In this document, the reviewer comments are in black, the authors responses are in red.

Summary: this paper presents single lidar measurements of multiple wind turbine wakes. A wind field reconstruction model is used to derive wake characteristics from the line of sight wind speeds. The presented model is an extension to multiple wakes of a previous model developed by the same research group to characterize a single wake. Results are presented for the decay of the velocity deficit and the increase of the wake width with downstream distance. The wake centerline is found to shift orientation with height, indicating stretching of the wake profile in veered flow. The results are interesting and add to the developing picture of wakes in wind farms.

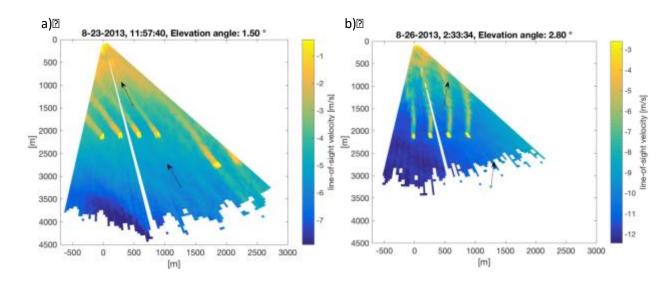
P6, L23: I suggest inserting "the assumed" in front of uniform ambient wind speed.

Thank you for the suggestion. We will add "the assumed" in the sentence.

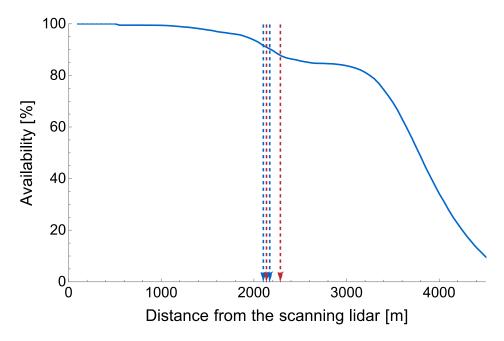
P9 L21: define the Pearson correlation coefficient and the mean squared error.

# We will rephrase the sentence as follows:

with Pearson correlation coefficient  $(corr(u_{LOS}, \hat{u}_{LOS}; g) = cov(u_{LOS}, \hat{u}_{LOS}; g)/\sqrt{cov(u_{LOS}, u_{LOS}; g)cov(\hat{u}_{LOS}, \hat{u}_{LOS}; g)}$ , where g represents the data weights) larger than 0.9 and mean squared error  $(MSE = \frac{1}{\sum_{i=1}^{n} g_i} \sum_{i=1}^{n} g_i(\hat{u}_{LOS,i} - u_{LOS,i})^2)$  lower than 0.5 are included in the final analysis of the results.

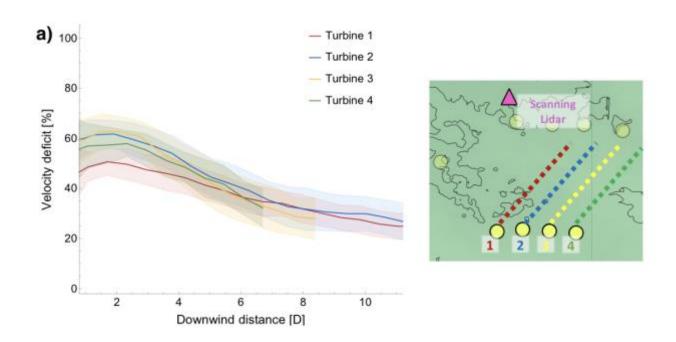
P10, Fig. 5: what do the corresponding plots of data availability look like? These could be important to include to understand if the some of the decrease in Figure 5 is driven by the measurements and not by wake characteristics. I would also like to know the number of scans included in the stable and unstable curve. Were there no neutral conditions?

P11, Fig. 6: are these plots along the wake centerlines? What was the wind direction and how was

it oriented with respect to the turbine row? This can be deduced from figures 8 and 9, but you might as well make it clear here.

Since we considered southwesterly (26 August 2013) and southeasterly (23 August 2013) flows, as the wakes go further from the turbines, they actually get closer to the scanning lidar (see scheme in Figure 1), so we are not concerned about data availability at long downwind distances (i.e. close to the lidar). However, the following plot showing data (line-of-sight velocity) availability for 23 and 26 August will be included in the Supplementary Material. The vertical dashed lines show the positions of the turbines. As can be seen, the data availability for all the range gates considered in Figure 5 (i.e. to the left of the dashed lines) is nearly 100%, and so our results are not affected by this possible issue.

Regarding neutral conditions, we will add the following sentence to the caption of the Figure: "(neutral conditions were detected only for very short periods, and are not included here)". So, nearly all the PPI scans performed during the selected days are included in Fig. 5.

Considering how we modeled each wake (equation 4) and how we defined the velocity deficit (equation 5) in the wake, the velocity deficit is by definition calculated at the location of the center of the wake – thus the wake centerline. Regarding the wind direction, it is stated in Section 2.1.1 that 26 August shows predominant southwesterly wind. However, as a reminder, the caption of the figure will include: "... 26 August 2013, southwesterly wind, ...".

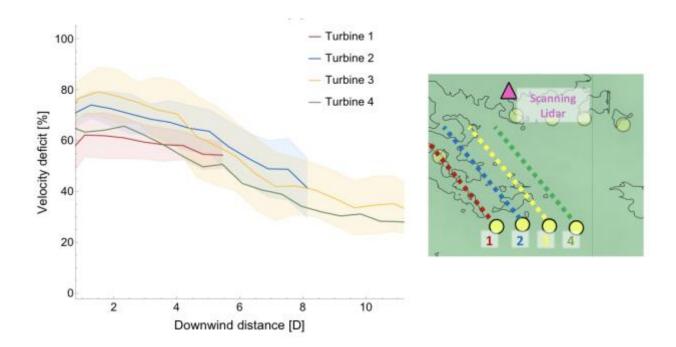
P11, Fig. 7: the authors should attempt to explain the differences they see. While the two outer turbines both have smaller deficits than the inner turbines, the difference in deficit between the two outer turbines is larger than the difference between the inner turbine and the outer turbine with the highest deficit. It would be useful to label the curves with the turbines they belong to. Could there be a relation with the vertical structure of the wakes and sampling the wakes at different heights. As stated above it is important to know how the different elevation tilts were combined (or not) in making this figure. Is the width of the shaded bands one or two standard deviations? I suggest making the same plot for the 23 August data.

We will change the Figure as follows to highlight the behavior of the single turbines:

The paragraph which introduces this new version of the Figure will be changed accordingly: "Figure 7 shows velocity deficit versus downwind distance from the turbines, calculated from the 276 (242) PPI scans, at all the elevation angles, performed during the whole night - stable conditions - of 26 (23) August 2013."

As can be seen, for the 23 August 2013 the difference between outer (turbines 1 and 4) and inner (turbines 2 and 3) wakes is more consistent for all the studied turbines, and the phenomenon noticed by the reviewer does not appear. Therefore, we cannot infer general results beyond what we stated in the paragraph: "wakes from outer turbines (number 1 and number 4), have lower velocity deficits than the wakes from inner turbines (number 2 and number 3), for relatively small downwind distances, with a difference up to 15%".

Regarding the use of different elevation angles, the caption of the Figure will include: "Velocity deficit vs downwind distance, for the four wakes of the studied row of turbines. Continuous lines represent the median values calculated from the PPI scans performed at all the considered elevation angles during the night (stable conditions) of 26 (panel a) and 23 (panel b) August 2013;".

Regarding the shaded bands, we will rephrase the description in the caption as "shaded areas show  $\pm$  one standard deviation of the data" (and the same was added for the caption of Figure 8).
